Project: Sydney Zoo- Western Sydney Parklands

Report: BCA Assessment Report

Date: 2nd November 2015

FIGURE 2.2 EXAMPLE OF AN ANGLE PARKING SPACE WITH SHARED AREA ON ONE SIDE ONLY—DIMENSIONS FOR AUSTRALIA ONLY*

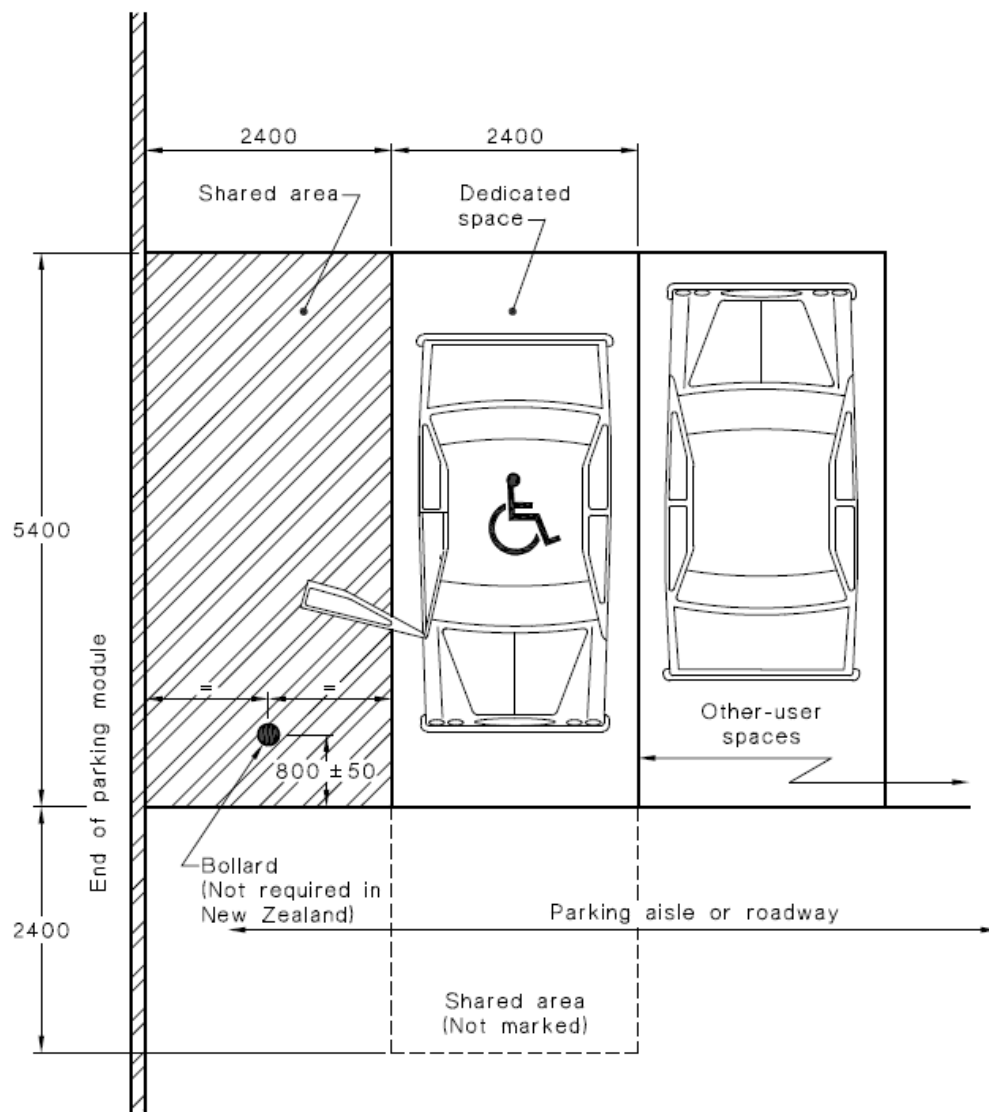
- 10 Accessible car spaces will achieve compliant headroom clearances in accordance with Clause 2.4 of AS/NZS 2890.6-2009
- 11 Bollards will be provided in the shared disabled car space area in accordance with Clause 2.2.1(e) of AS/NZS 2890.6-2009. Refer to Annexure B1 for a diagrammatic explanation.
